E/ECE/324
E/ECE/TRANS/505 } Add.1/Rev.4/Amend.3

Addendum 1: Regulation No. 1

Revision 4 - Amendment 3

UNIFORM PROVISIONS CONCERNING THE APPROVAL OF MOTOR VEHICLE HEADLAMPS EMITTING AN ASYMMETRICAL PASSING BEAM AND/OR A DRIVING BEAM AND EQUIPPED WITH FILAMENT LAMPS OF CATEGORIES R_2 AND/OR HS1

Figure 1

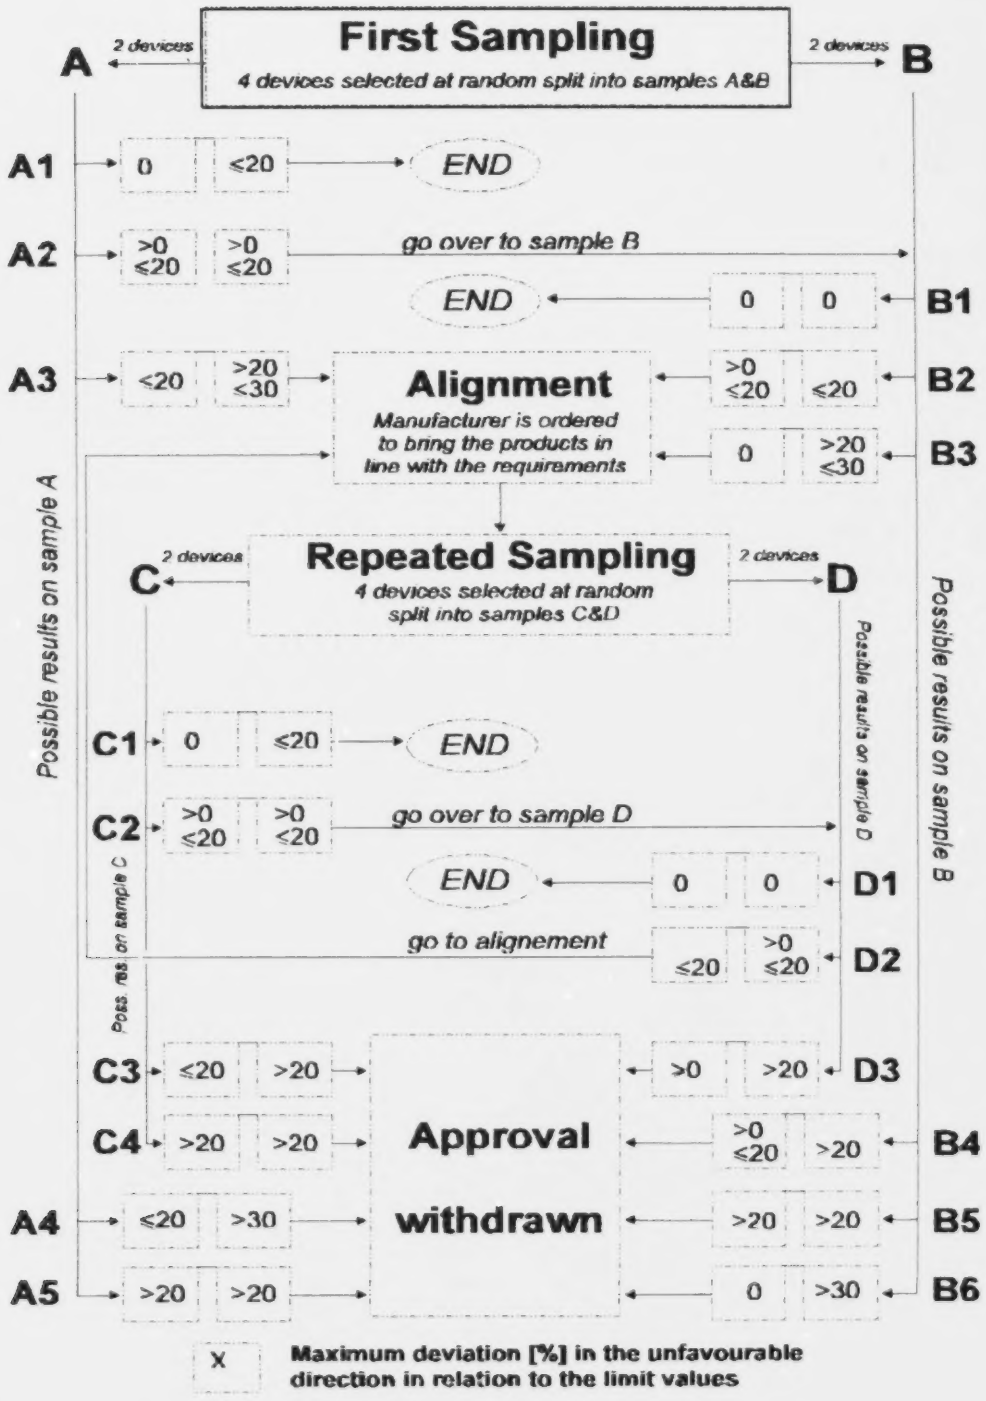
Add a new Annex 8, to read:

2.1.1. Following the sampling procedure shown in Figure 1 of this annex the conformity of mass-produced headlamps shall not be contested if the deviation of the measured values of the headlamps in the unfavourable directions are:

2.2.1. Following the sampling procedure shown in Figure 1 of this annex the conformity of mass-produced headlamps shall be contested and the manufacturer requested to make his production meet the requirements (alignment) if the deviations of the measured values of the headlamps are:

Conformity shall be contested and paragraph 10 applied if, following the sampling procedure in Figure 1 of this annex, the deviations of the measured values of the headlamps are:
